Access Compliance Report

Public Rights-of-Way

(Curb Ramps)

Intersection ID: 43753	Main Street: EARTHENWARE_DR	Cross Street: OLD_POTTERS_RD	Location: NE
ADA ID: 84BF363CBFAD	Ramp Type: Perp	Initial Pass/Fail: Fail	Overall Compliance: No
		Severity Score: 8.75

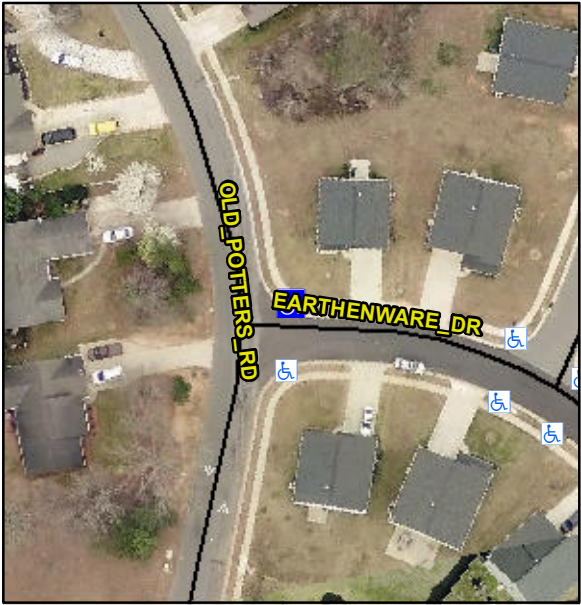
Codes/Mitigation Info/Possible Solution			Field Measurements/Component Compliance		
	Possible Solutions:		Compliance	Description	Data
	Remove & Replace Entire Ramp.		N/A	Ramp Length (in)	49.5
			No	Ramp Width (in)	46.5
			N/A	Flare Type LT	N/A
			N/A	Flare Slope LT (%)	N/A
			N/A	Flare Traversable LT?	N/A
			N/A	Landing Length (in)	N/A
			N/A	Landing Width (in)	N/A
			N/A	Landing Slope (%)	N/A
			N/A	Landing X Slope (%)	N/A
Surveyor Notes: N/A PROW/ADA: R304.5.1			N/A	Flare Type RT	N/A
			N/A	Flare Slope RT (%)	N/A
			N/A	Flare Traversable RT?	N/A
			N/A	DWS Provided?	N/A
			N/A	DWS Contrast?	N/A
			N/A	DWS Length (in)	N/A
			N/A	DWS Full Width?	N/A
			N/A	DWS Offset (in)	N/A
			N/A	Shared Landing?	N/A
			N/A	Gutter Ponding?	N/A
			N/A	Gutter Lip Ht (in)	N/A
			N/A	Painted X Walk1?	No
				X Walk 1 Direction	To S
			N/A	X Walk 1 Width (in)	N/A
				X Walk 1 Slope (%)	3.9
				X Walk 1 X Slope (%)	2.6
			N/A	Ramp inside XWalk1?	N/A

Road Slope (%)	N/A
				Road X Slope (%)	N/A
			N/A	Any Obstructions?	N/A
				Obstruction Type	
Total Cost:		\$ 1850.00			
			N/A		
			Yes	Surface Condition? (G/P)	Good
